AP1000 Design Certification Review

Westinghouse Electric Company

Advisory Committee on Reactor Safeguards

June 3, 2004

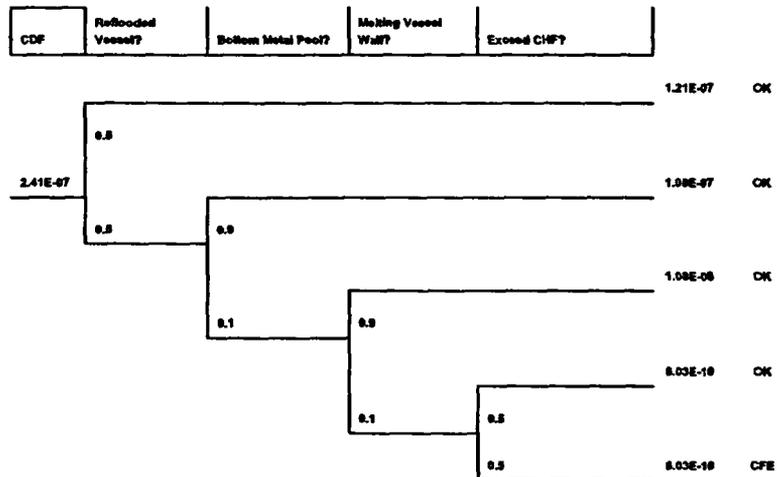
Bottom Metal Pool?

- **In-vessel debris relocation prevents large-scale mixing of molten Zr with UO_2**
 - Zr frozen at top of support plate
 - Oxide crusts prevent mixing
 - No uranium formation
 - No bottom heavy metal pool
- **Failure probability assigned = 0.1**

Issue 6: Organic Iodine Production

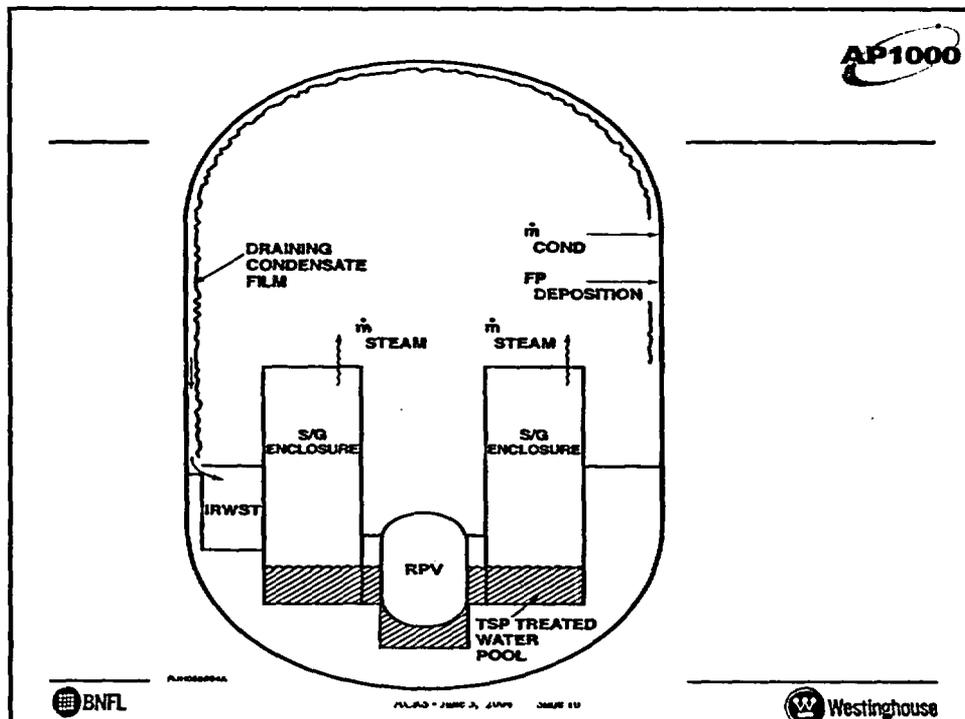
Organic Iodine Production: The acidification of containment water as a result of radiolysis of organic material could give rise to significant airborne fission product iodine in gaseous organic form. We need to review how Westinghouse and the staff have dealt with this potential.

- Formation of organic iodine as a result of radiolysis or organic materials involves the availability of elemental iodine (I_2).
- Elemental iodine can be produced from iodide (I^-) in water pools or films where pH is not controlled to be 7 or greater.

- AP1000 containment design includes TSP to control the pH of the water pool that collects in the lower compartment and reactor cavity following an accident.

- However, no specific pH control treatment for the condensate film draining down the containment dome and shell is provided.
- Cesium iodide can be deposited on the draining film and provide a source of I^- that could potentially be converted in the film to I_2 given the film was acidified.

- Film residence time depends on the steam condensation rate and limits the amount of film acidification and CsI deposition. A range of 40 to 260 seconds has been estimated for condensation rates of 29 to 2.3 kg/s.

Issue 6: Organic Iodine Production

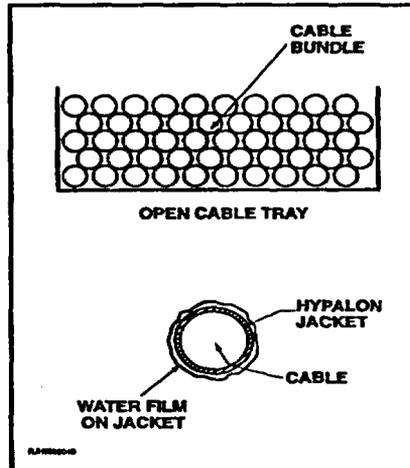
- Radiolytic decomposition of electric cable jacket material can produce HCl. If the HCl could escape the uncovered and covered cable trays, it could eventually mix with the containment atmosphere and be delivered to the draining film with the condensing steam.
